2017 PLANNING COMMISSION

Bellevue Planning Commission

7:50 PM – 9:30 PM	Study Session <u>1</u> <i>Downtown Livability – Review of Draft Downtown Land Use Code Amendment (LUCA)</i> Staff: Carol Helland, Land Use Director, Development Services Dept. Patricia Byers, Code Development Manager, Development Services Dept.;
-------------------	---

Emil A. King AICP, Strategic Planning Manager 452-7223
eaking@bellevuewa.gov *Planning and Community Development*

Figure 20.25A.090.A.1 (p.67) has been revised to reflect modifications requested by the Planning Commission.

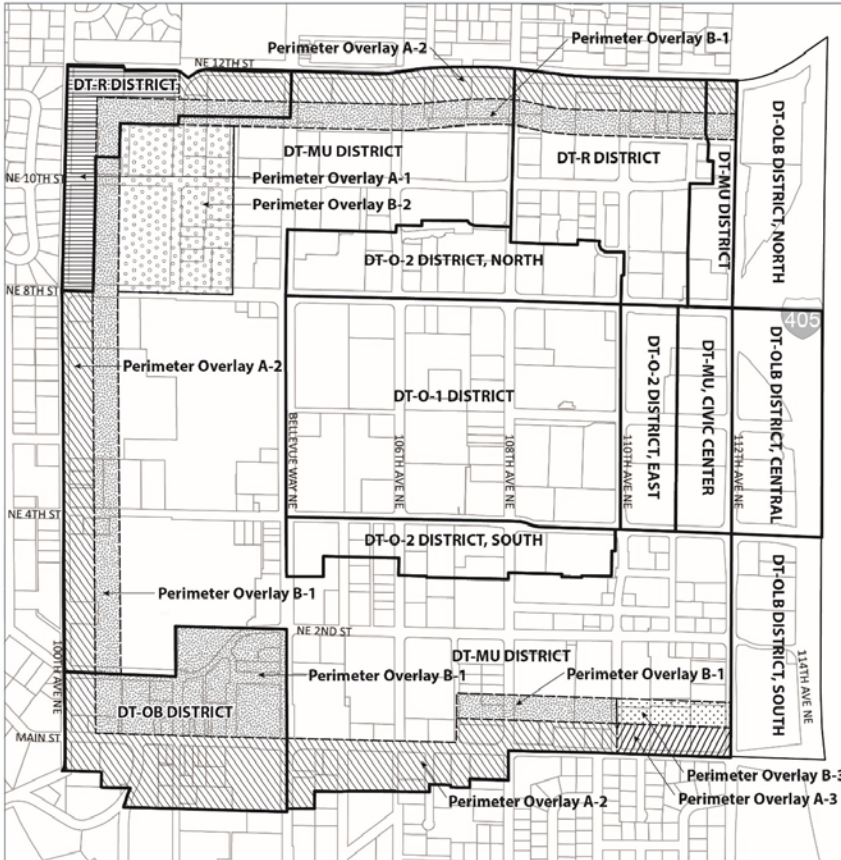
DIRECTION FROM THE PLANNING COMMISSION: Amend the Draft Code to change the Perimeter Overlay District A-1 to Perimeter Overlay A-2 in the area from 102nd Avenue NE to 112th Avenue NE.

The Planning Commission directed Staff to amend the Draft Code as stated above because McCormick Park created a buffer between Downtown and any residential development on the north side of NE 12th Street. In addition, the Planning Commission asked for a shade and shadow study, the results of which will be presented at the Planning Commission meeting on April 19th. McCormick Park runs on the north side of NE 12th Street from 112th Avenue NE to 102nd NE. However, from 106th Avenue NE to 102nd Avenue NE, it functions more like a landscape strip because of its narrow width. There are townhouses on the north side of NE 12th Street between Bellevue Way and 106th Avenue NE and apartment buildings on the north side of NE 12th Street between Bellevue Way and 102nd Avenue NE.

Commented [BT(3): April 19 Draft - Reflects Planning Commission direction.
